Access Compliance Report

Public Rights-of-Way

(Curb Ramps)

Intersection ID: 10037734	Main Street: SHADY_REACH_LN	Cross Street: N/A	Location: N
ADA ID: 5AFDF462CC76	Ramp Type: Directional1	Initial Pass/Fail: Fail	Overall Compliance: No
Severity Score: 22.5			
Codes/Mitigation Info/Possible Solution		Field Measurements/Component Compliance

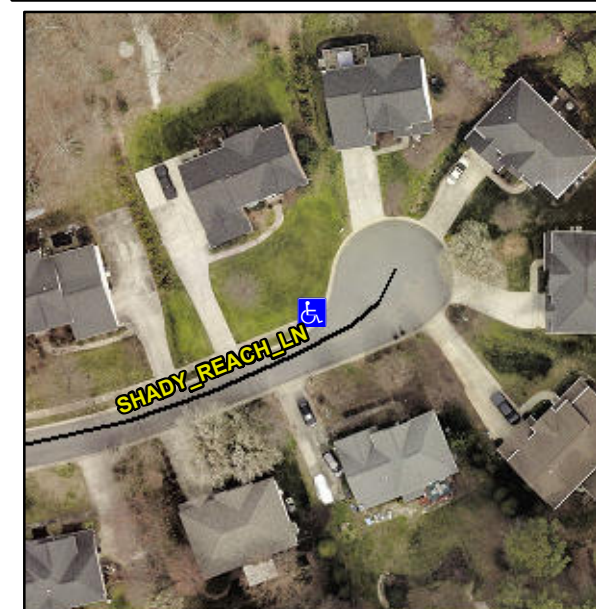
R304.5.1, R304.2.2, R304.5.3

Compliance	Description	Data	Compliance	Description	Data
N/A	Ramp Length (in)	20.0	N/A	Grade Break?	N/A
No	Ramp Width (in)	47.0	N/A	Grade Break Slope (%)	0.0
No	Ramp Slope (%)	11.8	N/A	Grade Break XSlope (%)	0.0
No	Ramp XSlope (%)	4.6			
N/A	Flare Type LT	N/A	N/A	Flare Type RT	N/A
N/A	Flare Slope LT (%)	N/A	N/A	Flare Slope RT (%)	0.0
N/A	Flare Traversable LT?	N/A	N/A	Flare Traversable RT?	N/A
N/A	Landing Length (in)	0.0	N/A	DWS Provided?	N/A
N/A	Landing Width (in)	0.0	N/A	DWS Contrast?	N/A
N/A	Landing Slope (%)	0.0	N/A	DWS Length (in)	N/A
N/A	Landing X Slope (%)	0.0	N/A	DWS Full Width?	N/A
N/A	Landing Curb? (Y/N)	N/A	N/A	DWS Offset LT (in)	N/A
N/A	Shared Landing?	N/A	N/A	DWS Offset RT (in)	N/A
N/A	Gutter Ponding?	0.0	N/A	Gutter Slope (%)	N/A
N/A	Gutter Lip Ht (in)	0.0	N/A	Gutter X Slope (%)	N/A
N/A	Painted X Walk1?	No		Road Slope (%)	5.2
	X Walk 1 Direction	To E		Road X Slope (%)	3.5
	X Walk 1 Width (in)	N/A		Clear Space?	N/A

Remove & Replace Entire Ramp.
